# AGENDA ITEM & RECOMMENDATION SUMMARY

AGENDA ITEM: Amended Plat: Los Olivos Subdivision, a recorded subdivision within the City of

Mission city limits, Applicant: Francisco Garcia and wife Mariana Garcia,

#### GENERAL PLAT NOTES:

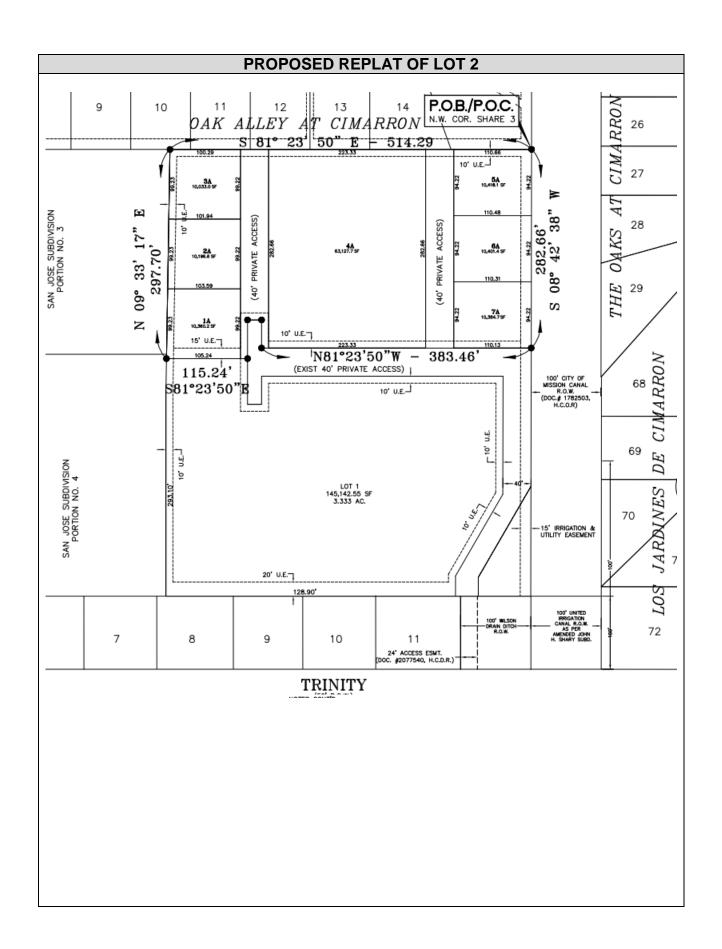
## **TO BE REMOVED**

- 12. A MAXIMUM OF 5 RESIDENTIAL LOTS ARE PERMITTED FOR THIS SUBDIVISION.
- EACH LOT IS REQUIRED TO PROVIDE ADDITIONAL 5 DEDICATED ON—SITE PARKING SPACES AT BUILDING PERMIT STAGE.

- The applicant proposes to amend the recorded plat of Los Olivos Subdivision by removing plat note # 19 which states that a maximum of 5 residential lots are permitted for this subdivision. (ATTACHMENT II)
- The purpose of this amendment is ultimately replat Lot 2 of Los Olivos Subdivision and making a 7 lot resubdivision. (ATTACHMENT III)
- The property has streets and infrastructure in place and is ready for building permits.
- The proposed replat will require a zoning change to comply with the new lot design and allow the issuance of building permits for the new lots created. (ATTACHMENT V)
- This amended plat will not require conditions or preapprovals from other City departments since its only removing a single plat note.
- Approval and issuance of this amending plat does not require notice therefore no public hearing is needed.
